**Sent:** 07 September 2025 14:13  
**To:** Katie Kurek  
**Subject:** DC/25/1155 Warnham  
**Attachments:** Road junction Knob hill.pdf  
**Categories:** Comments Received

DC/25/1155  
Land east of Tilletts Lane Warnham

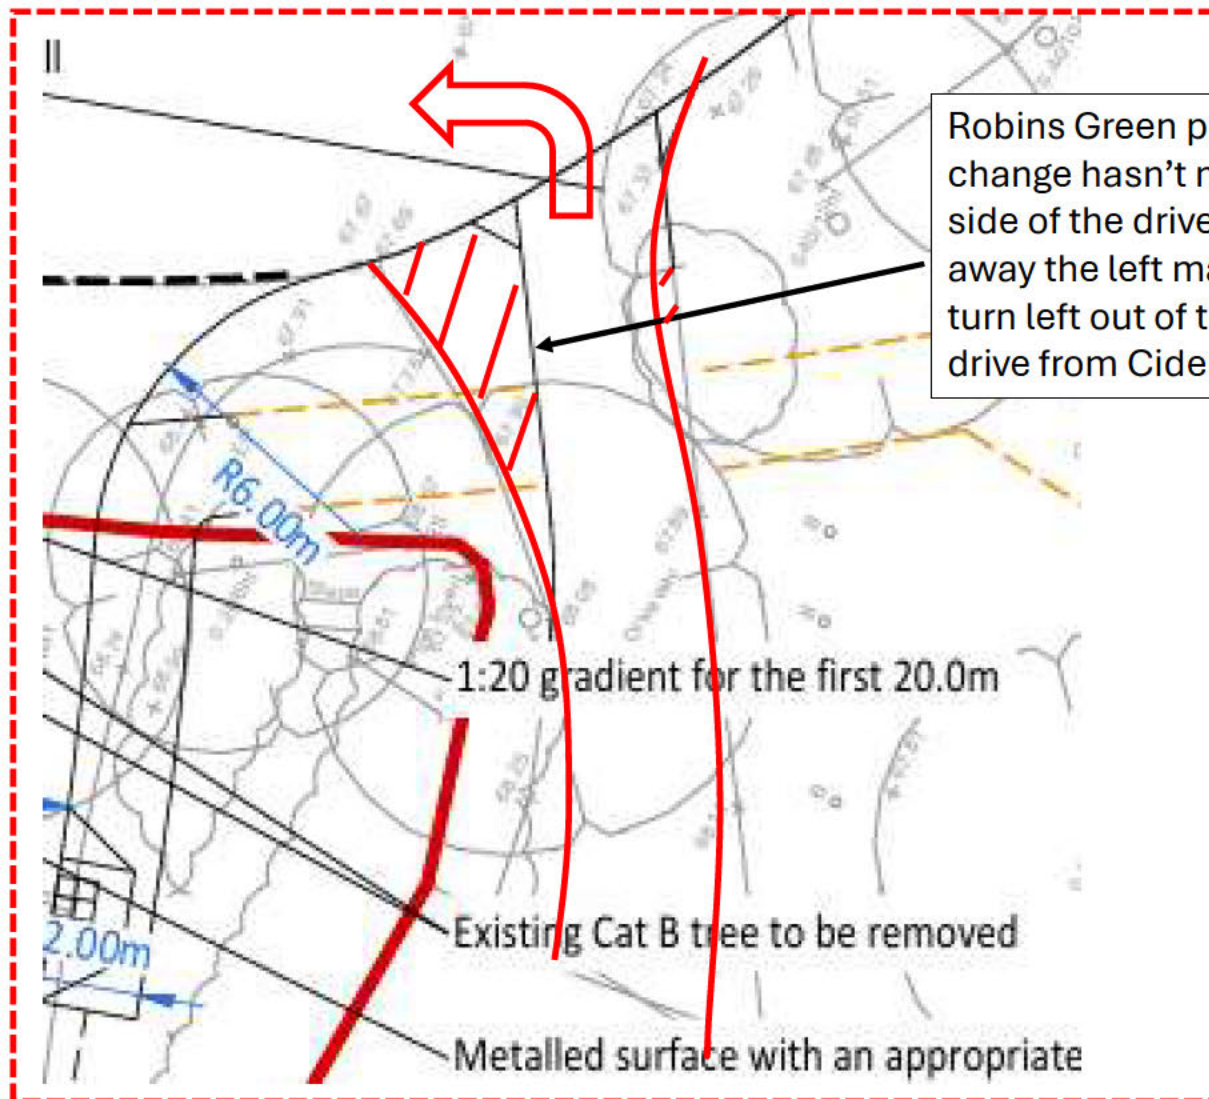
The drawings and plans attached highlight the new road alongside 2 driveways serving 3 properties, (Robins Green, Lowood and Oakridge)  
There is less than 10 metres from each driveway to the proposed road which will serve 40 homes, potentially 80 cars, plus all the deliveries, service vehicles and construction traffic

The drawings show that both driveways will be realigned to remove the sweep and therefore come straight on to the road, this will make an already dangerous road even worse for us to navigate as we will all have to pull out further into the middle to turn either left or right depending on the driveway! This will also be problematic for a return journey coming back on to the driveways.  
It is safe to say also that deliveries of which there are many, ( Service vehicles,Royal Mail, DPD, Amazon....etc! ) all park on the respective driveways rather than enter the property's boundary as well as refuse collections which I have highlighted in previous correspondence  
Again another hindrance to the visibility and safety for motorists exiting or entering the new development

The proposed road will merge onto the driveways of Robins Green and Lowood Oakridge driveways

Lowood Oakridge's  
proposed mitigation  
adjustment

Robins Green  
proposed mitigation  
adjustment

Robins Green proposed driveway change hasn't moved the right-hand side of the drive they have simply cut away the left making it dangerous to turn left out of the drive. Or enter the drive from Cider Mill end of Knob Hill
